Date: April 25, 2014

To: City of Madison Plan Commission

From: Jon Miskowski, Regent Neighborhood Association President, on behalf of the RNA Board
Shiva Bidar-Sielaff, Alder, District 5

Subject: Planning Division staff report on the University Avenue Corridor Plan

Map 16: Madison Comprehensive Plan Land Use and Proposed Changes

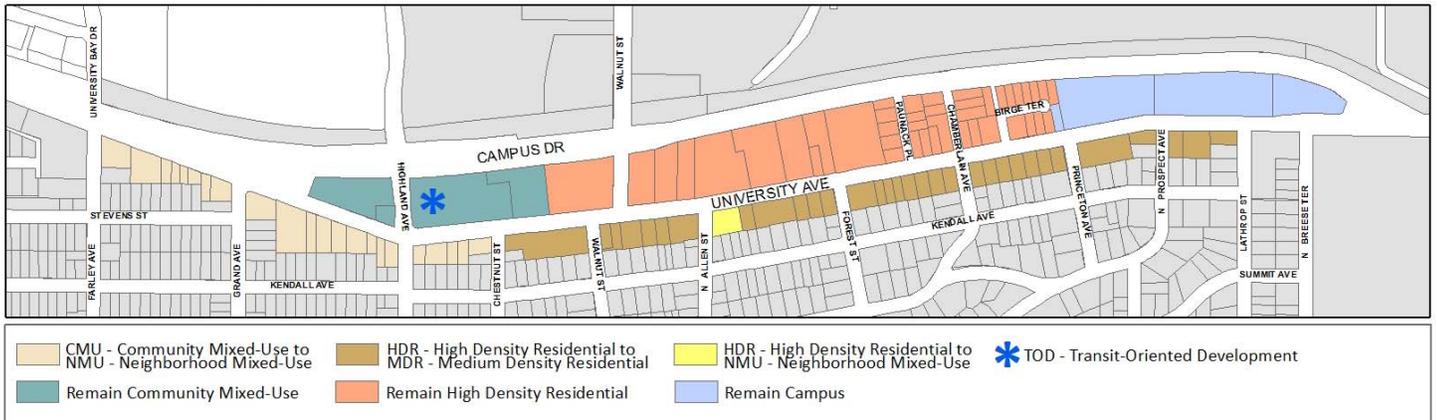
Revise Map 16, “Proposed Madison Comprehensive Plan Changes” (fig. 4 on p. 6 & text on p.11 of staff report, p. 47 of UAC Plan) and associated narrative in the Plan as follows:

- a) Same as in staff report
- b) Maintain the Comp Plan designation for the areas north of University Ave

Note: This recommendation reflects agreement among staff and us on the change of designation for the areas south of University Avenue (see attached proposed modified map).
